Subject: FW: 1333 Bullock Rd./3 Lot Subdivision

I'm writing about a driveway change to a 2021 approval for a 3 lot subdivision of my property at 1333 Bullock Rd. in Georgia. I've included clips below of the plans showing the original driveway location off Bullock Rd. (from the 2021 approval) and the proposed driveway location off Georgia Shore Rd. (2023 proposed redesign). I called and talked to Doug at the Town about the approval process for the revised driveway location for Lot 1, and he suggested that I start with discussions with both of you first before applying for a site plan amendment. The reason for the change is that we've heard feedback from potential buyers of Lot 1 that they don't want a shared driveway or shared road maintenance responsibilities.

Proposed Driveway Below:

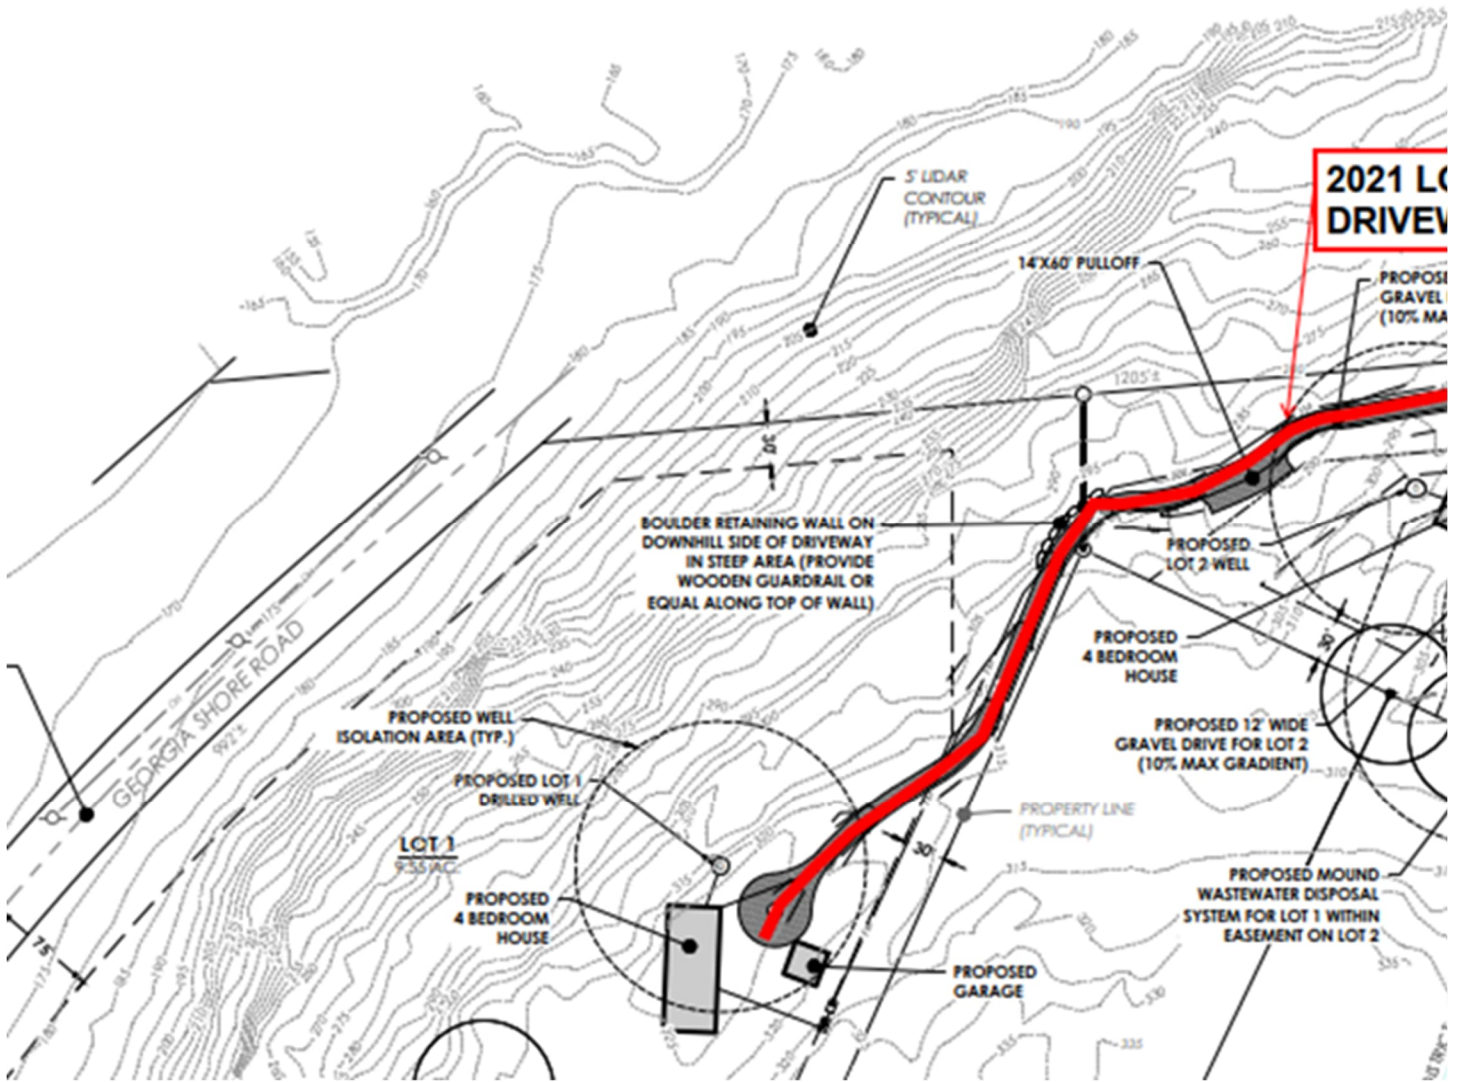
Like I had stated before, as long as it meets the state B-71 driveway standards I'm good with it. I always try to stress that the required sight distance needs to be met and maintained. If you can put a couple of grade stakes where the Georgia shore driveway is I can take a better look.
